KMR.CDD.MIQ.1932-1933.01 B

With reference to your application dated...15-5-33...193
with a plan for the proposed building additions and alterations on plot
No. 147, 148 Survey Sheet No. M.R.1. Market Quarter
I have to request you to comply with the following requirements:—

PLAN OF PROPOSED ADDITIONS & ALTERATIONS
ON PLOT NO. 147 & 148. M-R-1.

Re. Plot no. 147 & 148, M.R. 1, Market Qtr.

SECOND FLOOR

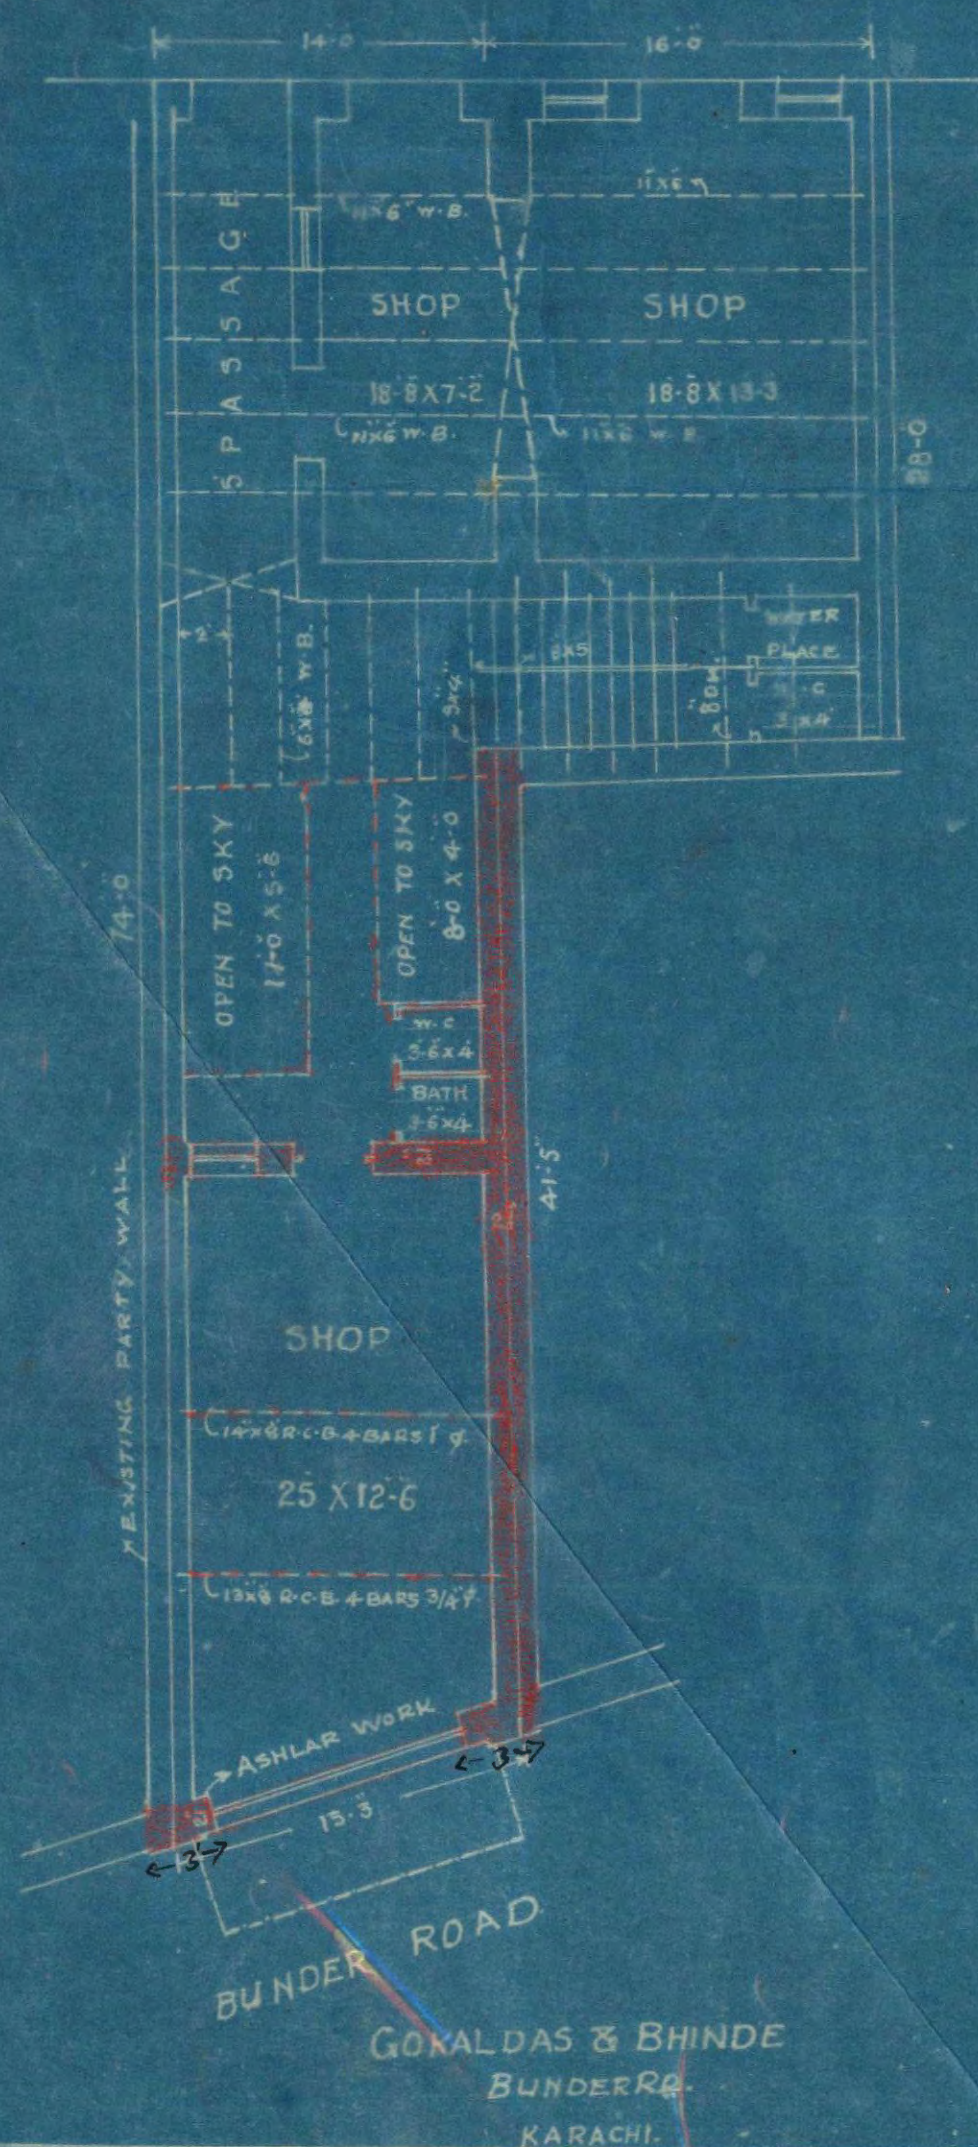
- 1) Rights of party wall be produced & the existing owner's signature be required in the plan.
- 2) R.C. beams ^{carrying passages & Samsan block} with their dimensions & reinforcement be specified.
- 3) We in the ground floor behind stairs is against the wall.
- 4) Stairs be made fire proof.
- 5) Existing balcony will have to be jointly measured & its measurement & position settled. It will be allowed in its present position & of the same dimensions. ^{A photo be taken} 5 photos plan be prepared.
- 6) Kitchen behind stairs are dark.
- 7) Section line be fully shown.
- 8) The dimensions of the existing balcony as shown in section separated are not correct.

- 1) width of road be given
- 2) measurements must be corrected
- 3) Plots must be amalgamated

1. Right of party wall be produced and the adjoining owner's signature is required on the plan.
2. R.C.C. beams carrying passages and sanitary block with their dimensions and reinforcement be specified.
3. W.C. on the ground floor with stairs is against the rules.
4. Stairs be made fire proof.
5. Existing balcony will have to be jointly measured and all measurements and position settled. It will be allowed on its present position and of the same dimensions. A photo thereof be taken.
6. Kitchen behind stairs are dark.
7. Section line be fully shown.
8. The dimensions of the existing balcony as shown in section separately are not correct.
9. Width of roads be given.
10. Measurements must be corrected.
11. Plots must be amalgamated.
12. Front pillars must be 3' in widths.

1. Objections 1 to 5, 9, 10 & 12 are complied with.
2. As regards no. 6, the kitchens are in the existing portion and not proposed new.
3. As regards no. 8, this will be settled personally.
4. As regards no. 11, the plots ~~already~~ are one and no amalgamation is necessary.
